Everett Link Extension

Early Scoping Summary Report

March 2022

Figure 5-1 Potential Alternatives for the Everett Link Extension – West Alderwood

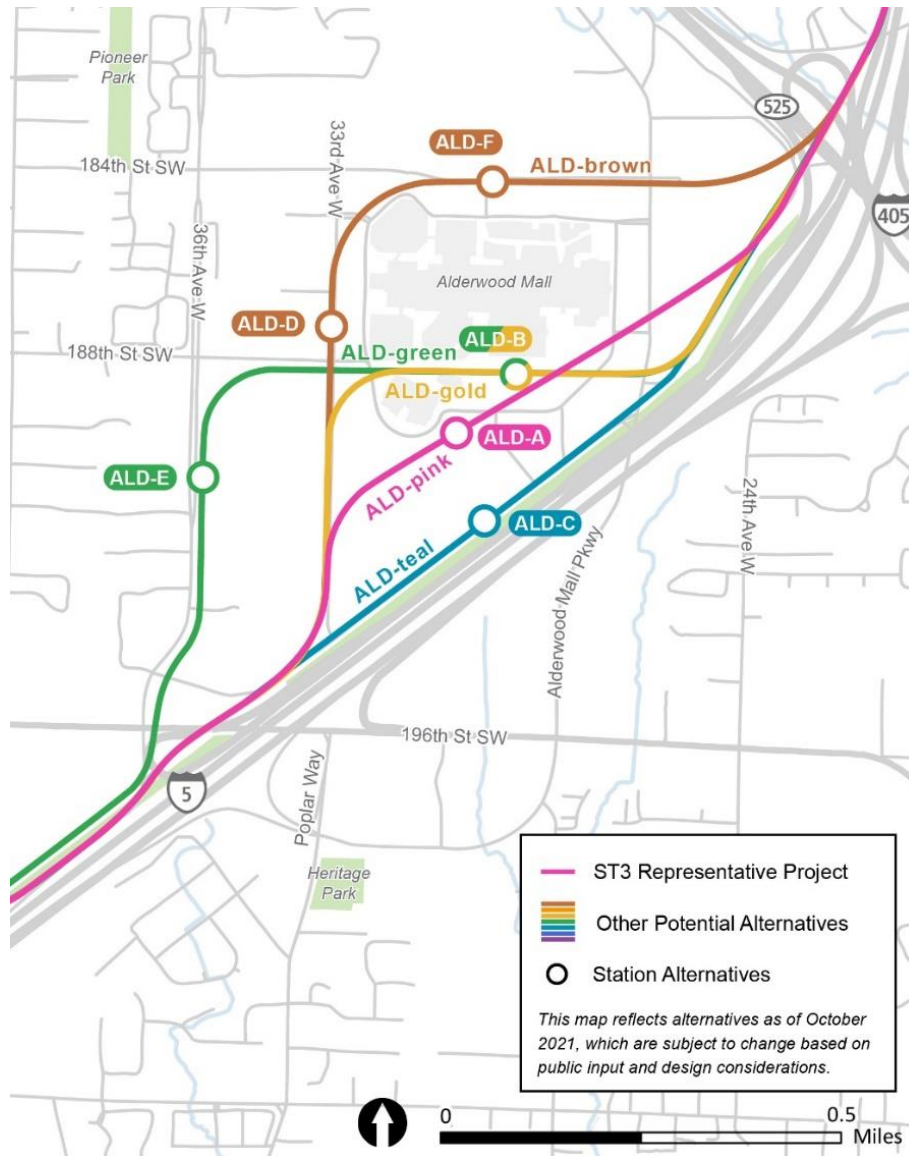
Sound Transit received 53 communications and 88 comments related to West Alderwood alignment and station alternatives, with the vast majority of comments related to stations. Station ALD-F received the greatest number of comments (27) with 24 in support of the station location, followed by ALD-D with 14 supportive comments (of 17 total). ALD-C received the highest number of comments opposing the site (8 of 14).

Theme	Specific Comments/Suggestions
Ridership	8 comments cover topics related to ridership potential. Most focus on the location of the station in relation to future TOD and access to the Regional Growth Center (specifically Alderwood Mall). Some express concern that ALD-C and ALD-E would not be walkable for a very large population due to single family residential or highway proximity. ALD-D and ALD-F received the greatest support based on ridership potential.
Traffic/Parking	6 comments mention park-and-rides or parking lots, with an additional comment worried about station access and transit integration on nearby congested roadways. Of the parking comments, most state that current surface lots would be good locations for future station or park-and-ride infrastructure.
Land Use/Station Area Design	25 comments at West Alderwood involve land use – the most of any station area. Many comments focus on access to existing retail and housing, or future TOD and housing potential. ALD-A, ALD-B and ALD-C were mentioned as limiting TOD potential, while ALD-D and ALD-F were thought to provide the greatest TOD potential.

Figure 5-2 Potential Alternatives for the Everett Link Extension – Ash Way

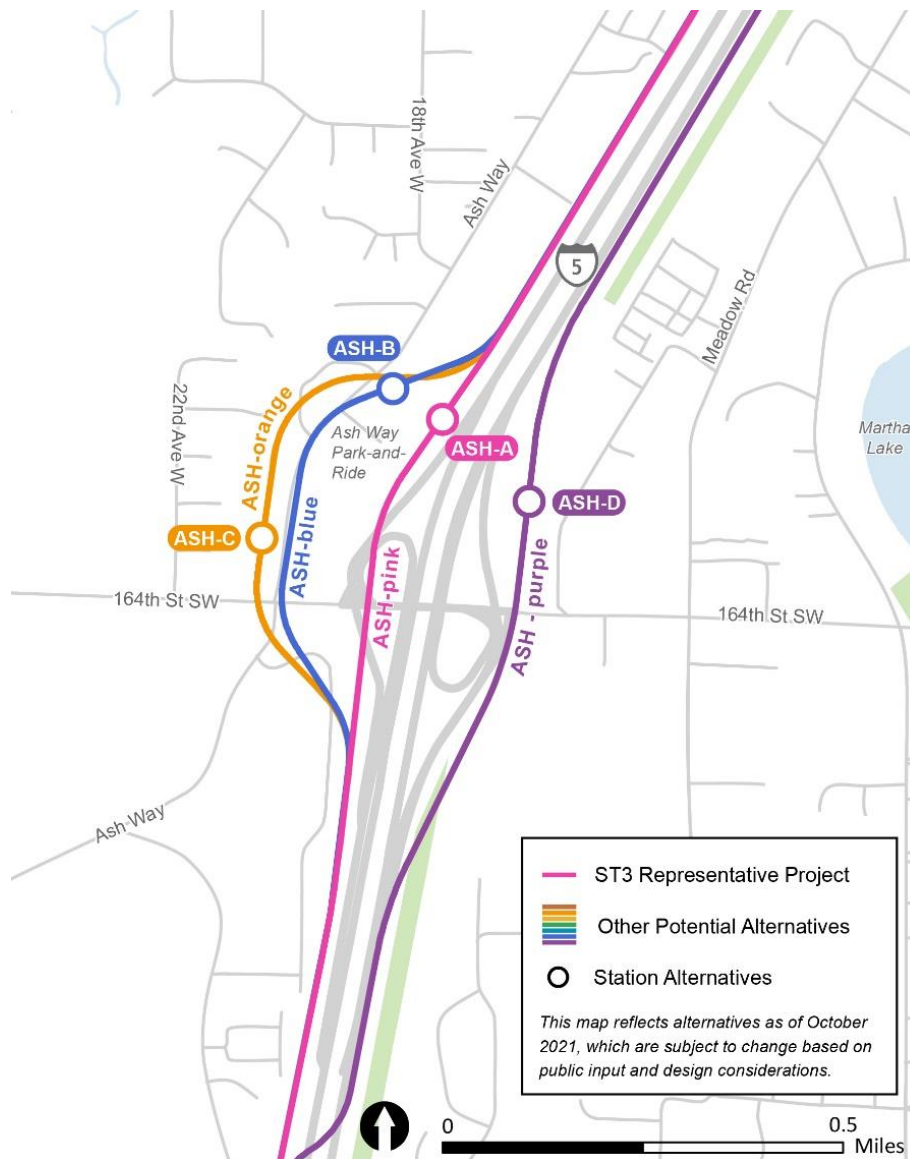
Sound Transit received 57 communications and 107 comments regarding alignment and station alternatives at Ash Way, with most comments related to stations. Station ASH-D received the greatest number of comments (38); of those, 17 were in support of the station location and 14 opposed the site. Each of the other station options received less than half of ASH-D's total, with ASH-A and ASH-B receiving similar numbers of supportive comments (15 and 13 respectively). ASH-C received the least support, with six (of 19) comments opposing the site and six supporting the site.

Figure 5-5 Potential Alternatives for the Everett Link Extension – SW Everett Industrial Center

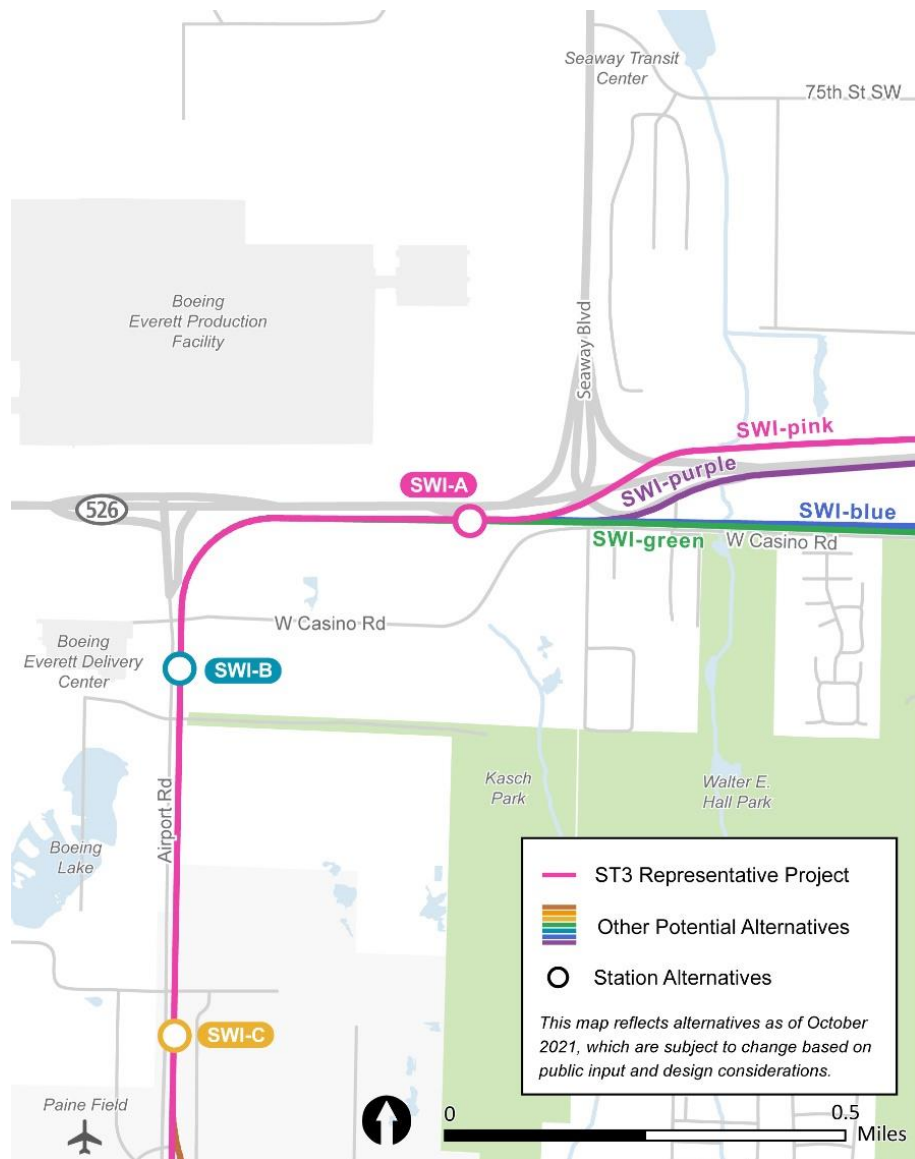
Sound Transit received 82 communications and 169 comments for station and alignment alternatives in the SW Everett Industrial Center station area. SWI-A received the most comments (22); of those, 11 supported the station location and four opposed it. SWI-C received almost as many comments (20) but received the most supporting comments (12) with three opposing. SWI-B had three opposing and two supporting comments out of 10 total comments.

Theme	Specific Comments/Suggestions
Cost and Schedule	15 comments relate to project cost and schedule at the SW Everett Industrial Center Station. The comments all focus on the added expense and delay to the project schedule, as well as the additional trip time from serving Boeing and Paine Field.
Ridership	24 comments mention ridership at SW Everett Industrial Center Station. Commenters generally expressed skepticism that sufficient ridership to justify a station could be found in the station area.
Traffic/Parking	6 comments mention traffic in the SW Everett Industrial Center station area. Comments are mostly positive about the impacts that light rail service could have on traffic by replacing car trips to Boeing and the airport, though some express concern about taking traffic lanes.
Land Use/Station Area Design	18 comments relate to land use in the SW Everett Industrial Center station area. Most of the comments express concern that the land use in the industrial center would not be easily accessible by transit, no matter where the station is located.

Figure 5-6 Potential Alternatives for the Everett Link Extension – SR 526/Evergreen

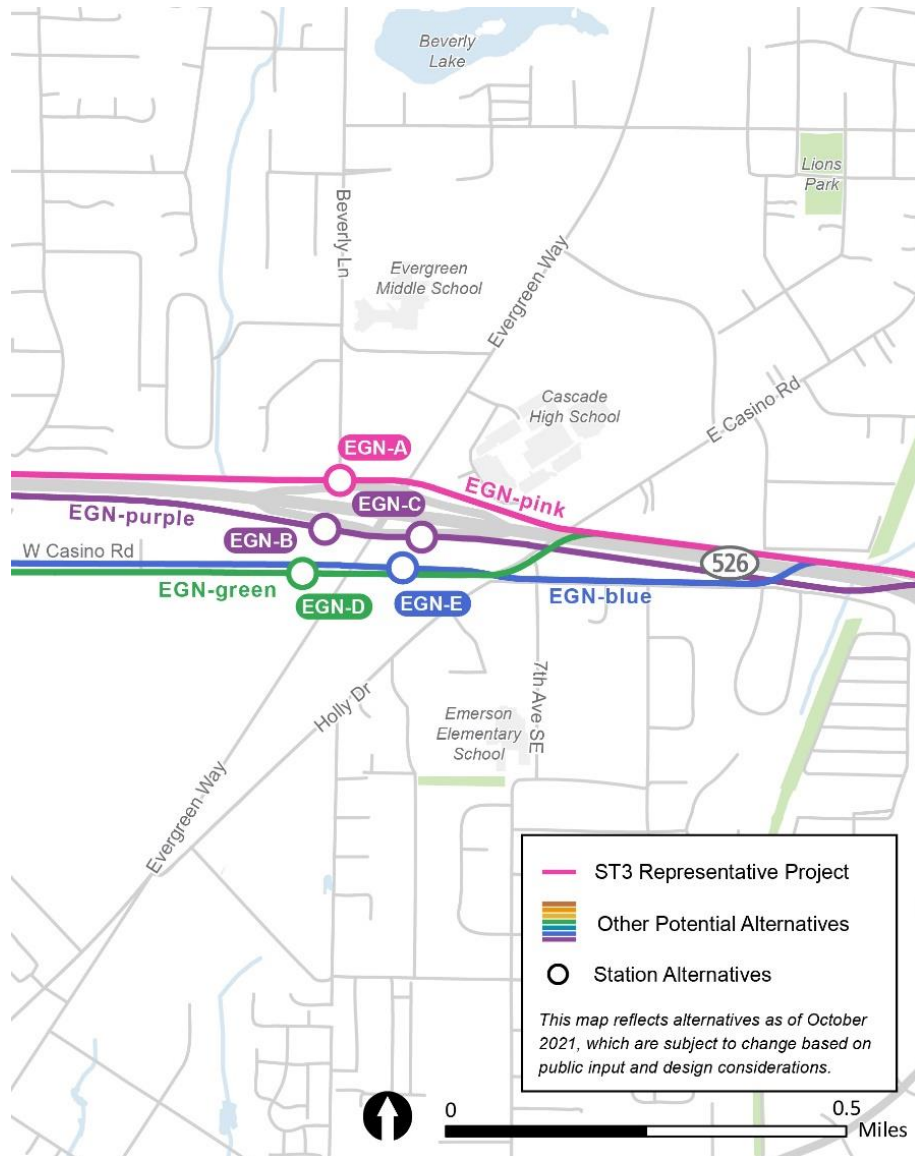
Sound Transit received 60 communications and 103 comments related to the SR 526/Evergreen alignment and station alternatives. EGN-A had the most comments of the station areas (18), and it had the most positive comments with 13 in support and three opposed. EGN-B received the second highest number of comments (11), with nine in support and two opposed. EGN-D received 10 comments with six in support and three in opposition. EGN-C received eight comments with five in support and two against. EGN-E got the fewest comments with five total, two in support and three in opposition.

Figure 5-7 Potential Alternatives for the Everett Link Extension – Everett

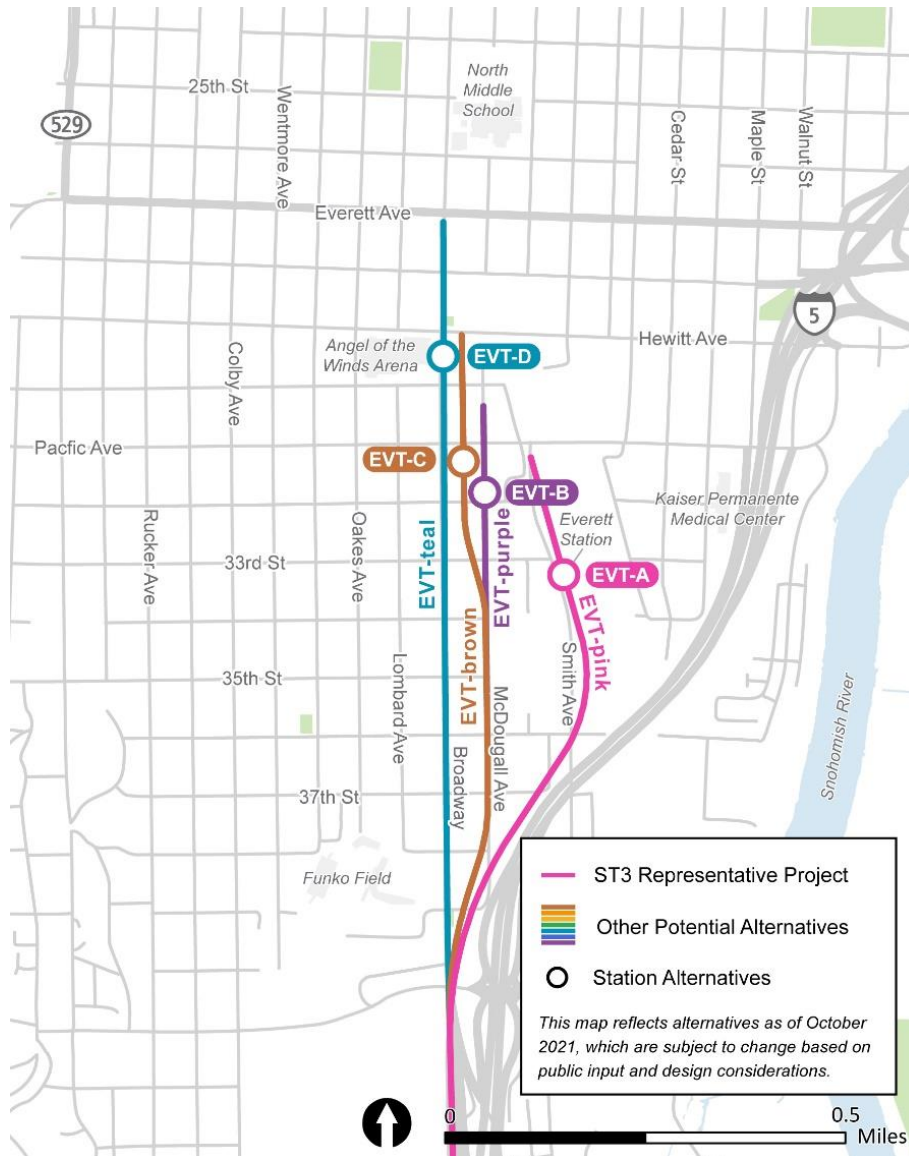
Sound Transit received 70 communications and 139 comments related to the Everett alignment and station alternatives. EVT-A received the most comments (27) and the most supporting comments (19), with three comments opposing this location. EVT-D and EVT-C had the lowest number of comments with 18 and 19, respectively, but EVT-D had more negative comments (four versus two for EVT-C).

Figure 5-8 Potential Alternatives for OMF North

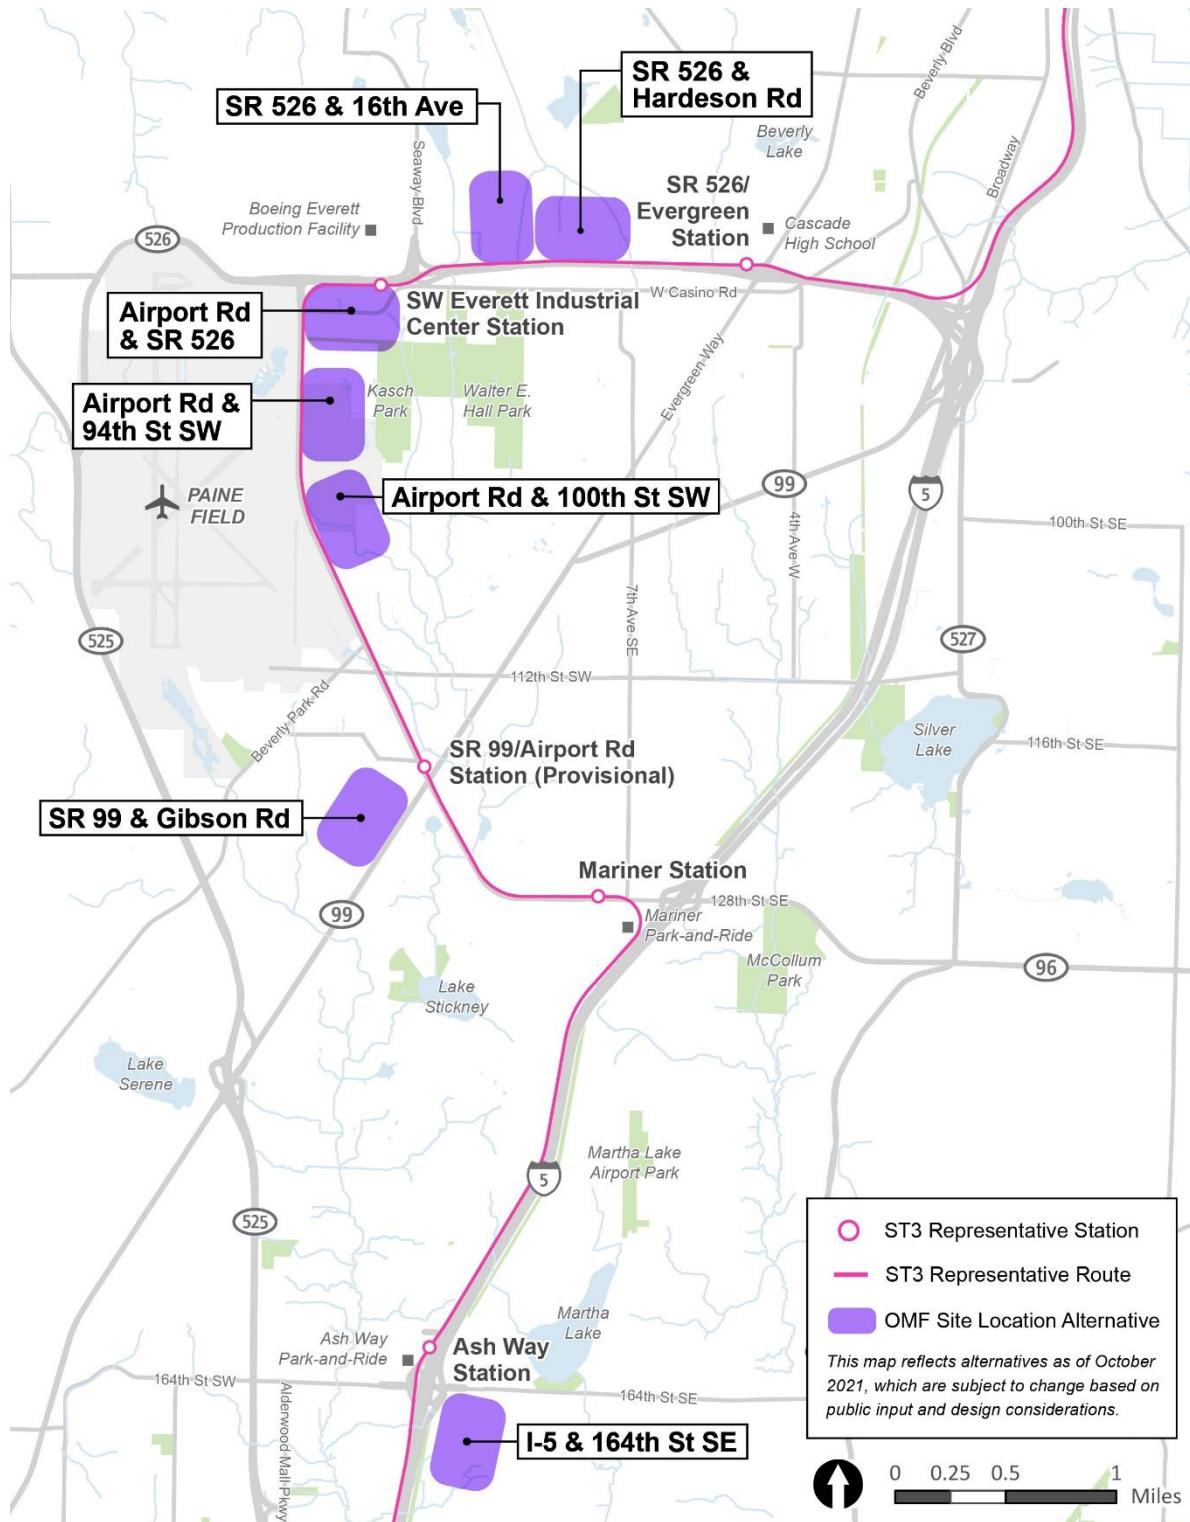
Agency	Major Comment Themes
	<ul style="list-style-type: none"> Integration of bus and rail transit should include incorporation of the entire customer journey into design. Remove the SR 526/Airport Road OMF site (shown in Figure 5-8) from consideration. This site encompasses facilities that are essential for Community Transit to provide the necessary local bus network to support Sound Transit's ridership goals. Prioritize the provisional station at SR 99/Airport Road. Community Transit's Swift Blue Line and Swift Green Line corridors meet at this location and their combined "network effect" makes it one of the highest transit ridership locations in Snohomish County. Bus bays must provide adequate capacity to support future service levels and to support seamless bus-to-rail and bus-to-bus customer connections for our shared customers. <p>Community Transit also provided detailed comments on the alternatives in each station area in an attachment to its comment letter.</p>

Sound Transit received 54 communications and 98 comments related to OMF North site alternatives. Overall, sites along Airport Road received the most support. Airport Road and 100th Street SW received 13 supportive comments, Airport Road and 94th Street SW received 11, and Airport Road and SR 526 received 10. Sites receiving the fewest number of supportive comments include SR 526 and Hardeson Road (five), I-5 and 164th Street SE (eight), and SR 526 and 16th Ave (eight). I-5 and 164th Street SE received the most comments in opposition to the site location (eight), followed by Airport Road and SR 526 (five).

Exhibit 1: Metro Everett LT Concept Plan

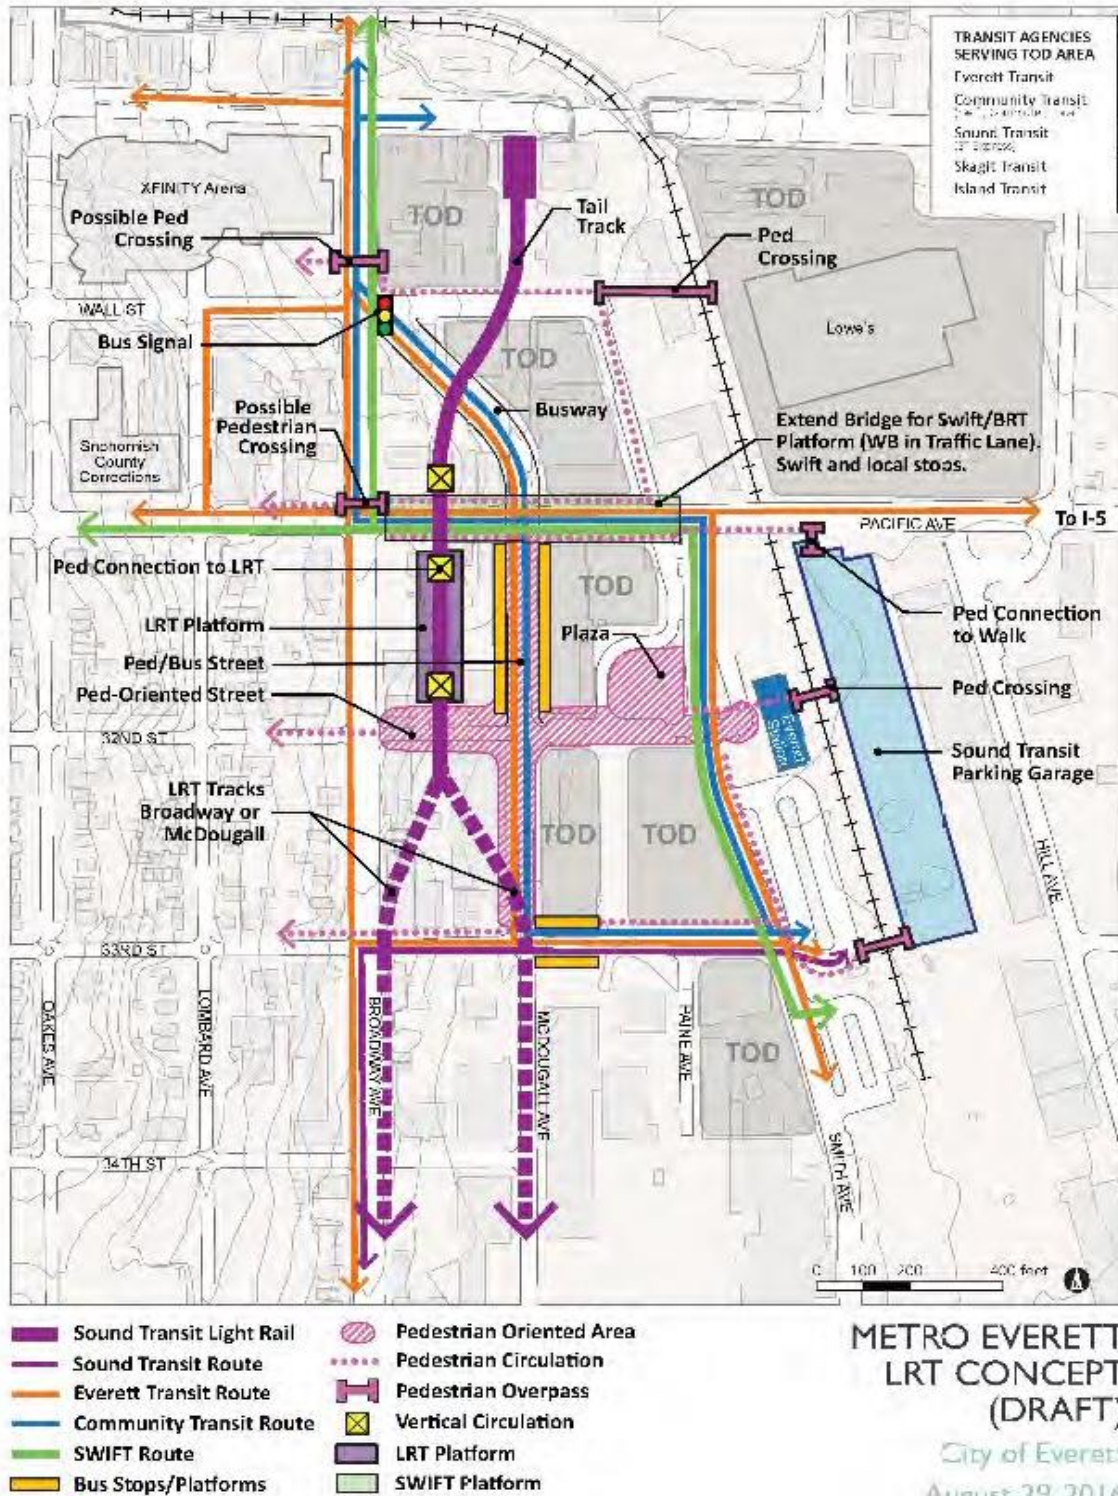
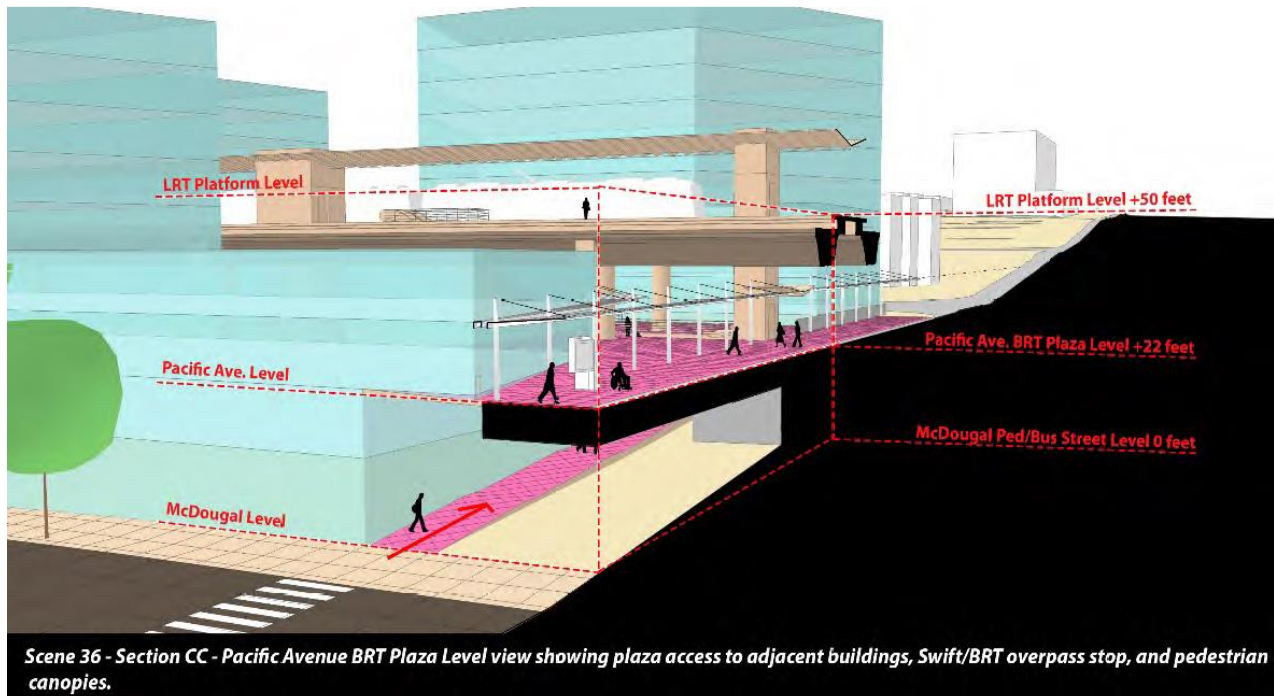
This concept of the light rail station facing southwest from Pacific shows the location of light rail and transit-oriented development between Broadway and McDougall
